OUTSTANDING DESIGN CONCERNS

PREVIOUS LUR 1 SUBMISSION - NORTH LANDSCAPE SITE PLAN: WHAT WE HEARD

LUR 2 - NORTH LANDSCAPE SITE PLAN RESPONSE

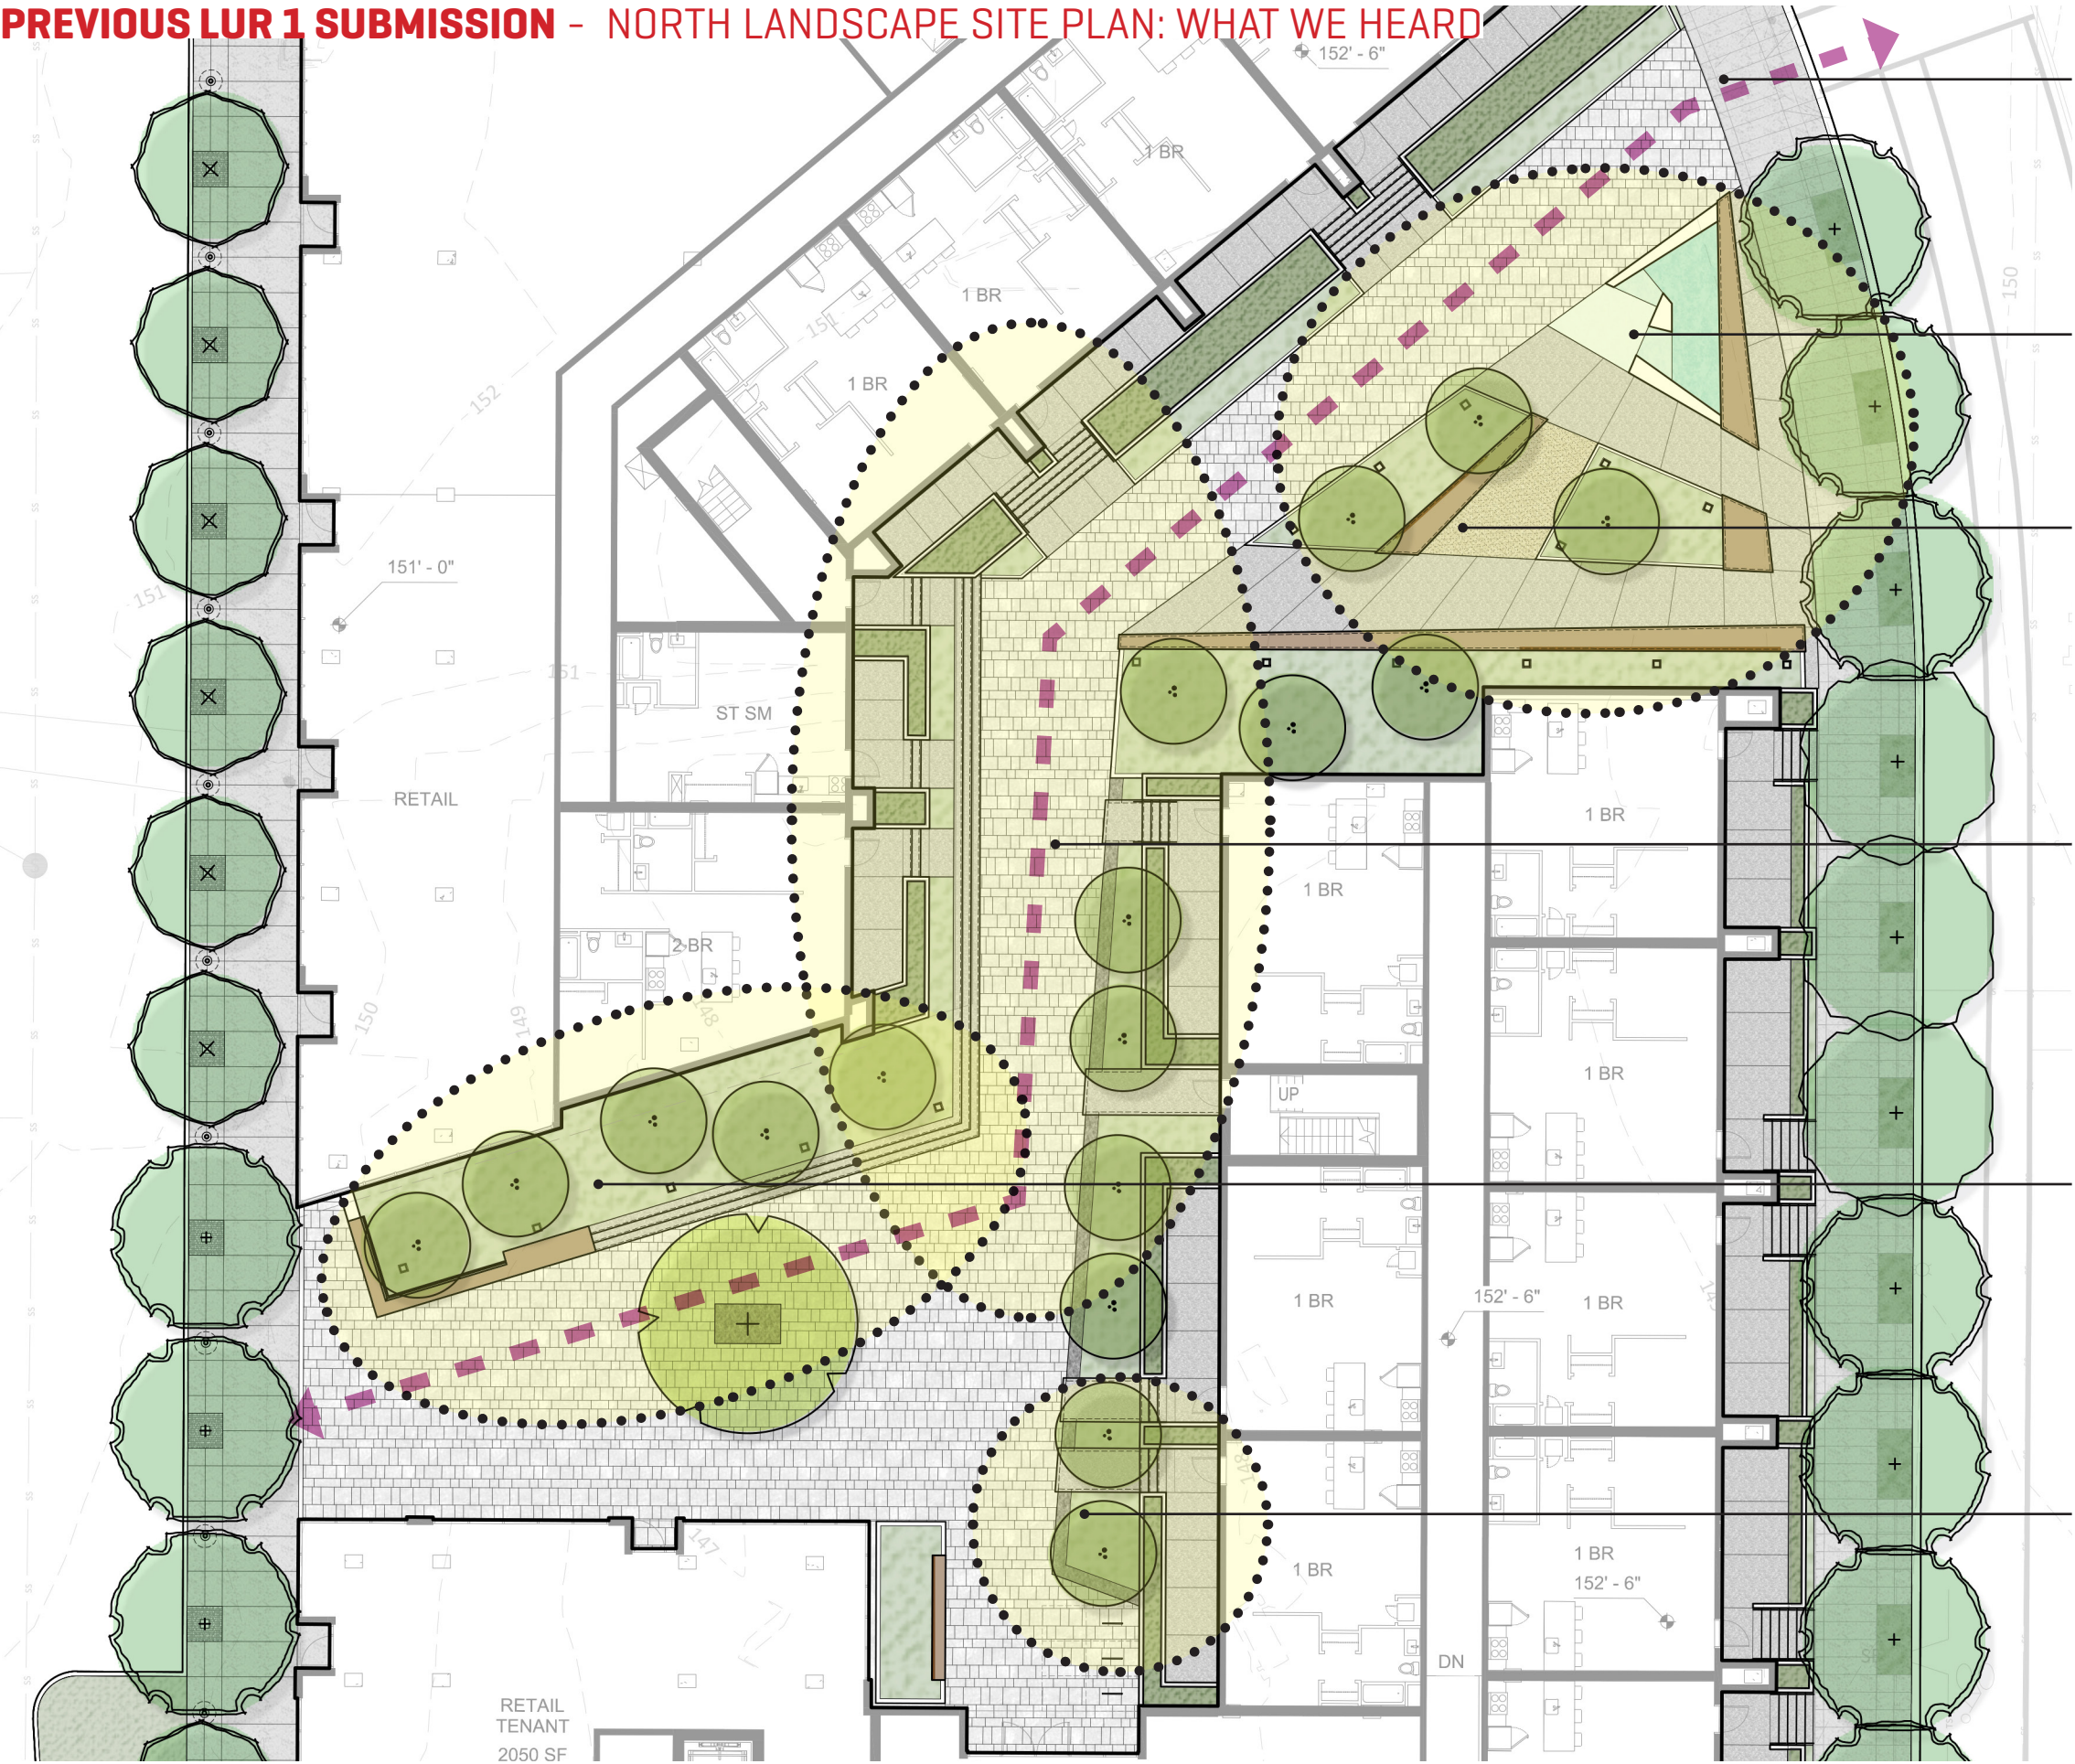
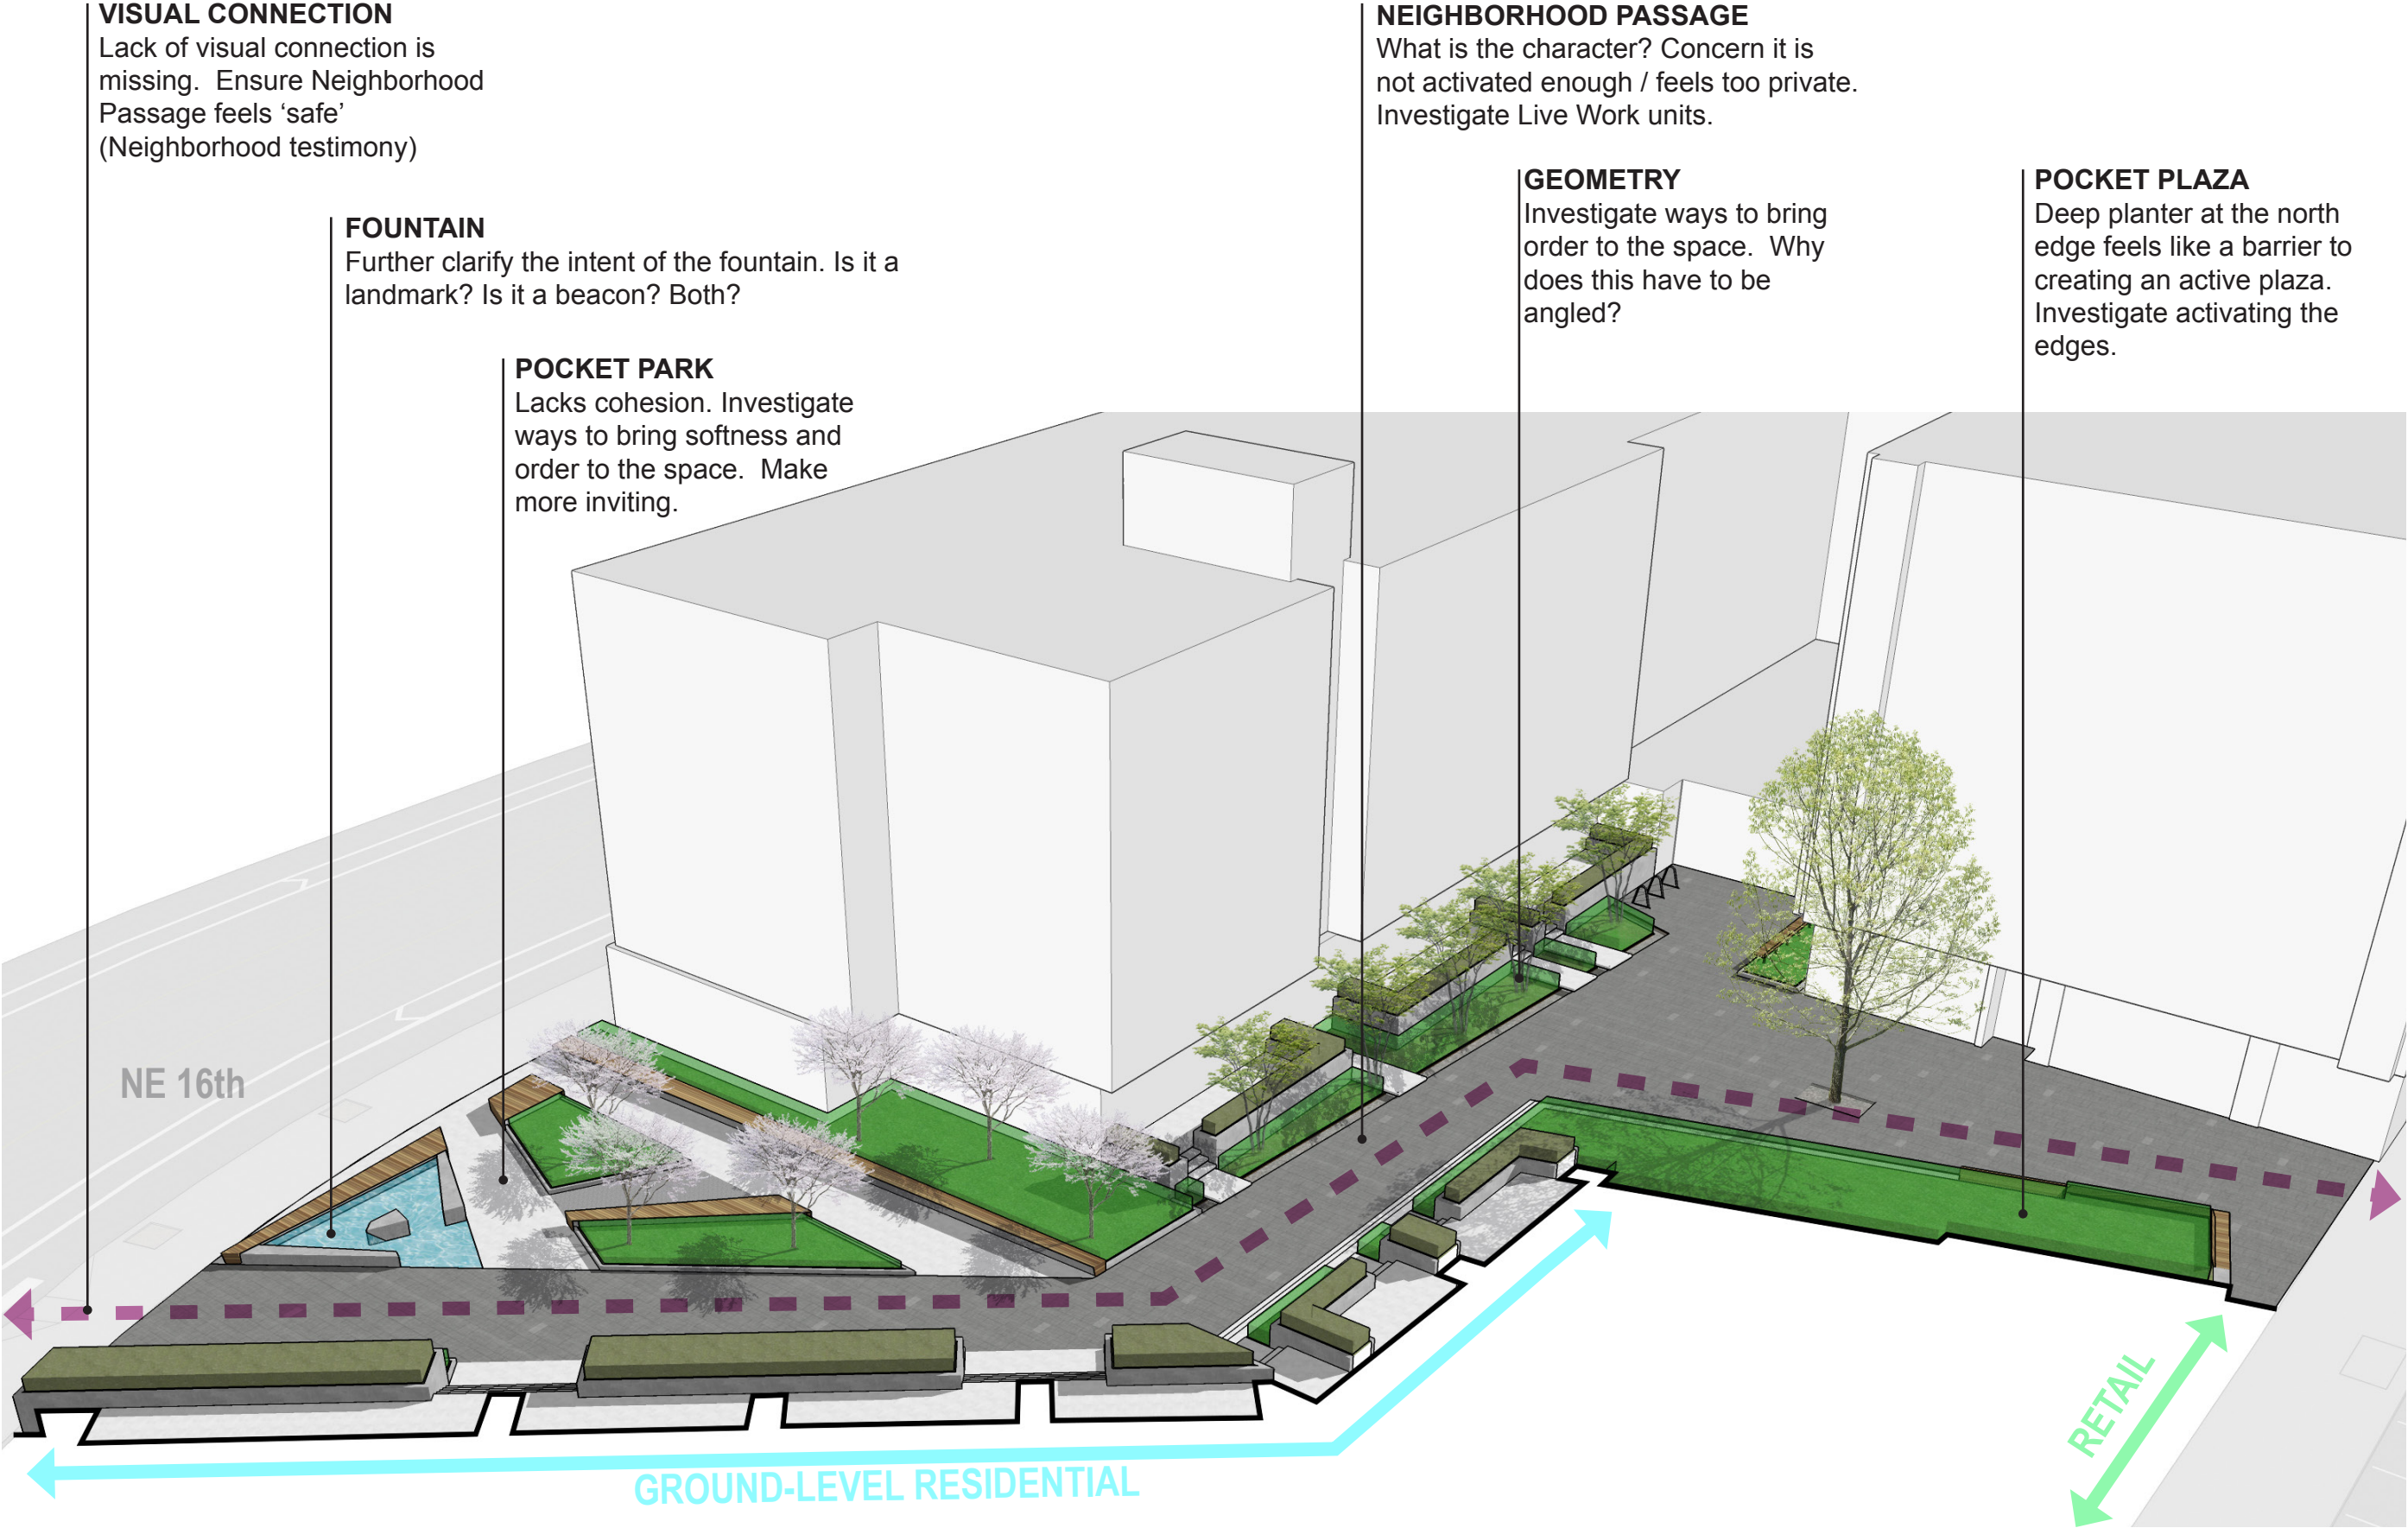
Visual connection is missing. Ensure Neighborhood Passage feels 'safe' (Neighborhood testimony)

Further clarify the intent of the fountain. Is it a landmark? Is it a beacon? Both?

Lacks cohesion. Investigate ways to bring softness and order to the space. Make more inviting.

What is the character? Concern it is not activated enough / feels too private. Investigate Live Work units.

Deep planter at the north edge feels like a barrier to creating an active plaza. Investigate activating the edges.

Investigate ways to bring order to the space. Why does this have to be angled?

VISUAL CONNECTION
Buildings and landscape beds have been adjusted to allow for a view from the crosswalk on 16th through the site to the theater along 15th.

FOUNTAIN
The revised fountain provides a meeting place as well as a visual icon for the site and pocket park.

POCKET PARK
Park has been opened up to allow for free flowing movement through stone paving and a tree grove in crushed stone paving. Majority of areas are flush and walkable including the water feature. A planting area flanks the park to the south to create a buffer for the residential units.

NEIGHBORHOOD PASSAGE
The neighborhood passage has been shortened with the architecture on the north building being pulled back. Live/work units now activate the north building face.

POCKET PLAZA
Plaza has been opened up to allow for free flowing movement throughout. Shade trees in crushed stone paving create an active gathering space for the adjacent retail to the south and live/work to the north.

GEOMETRY
Angles in the landscape plan have been refined to provide more clarity of path of travel and spatial edges. Sharp points in the plan have been minimized to create more inviting spaces.
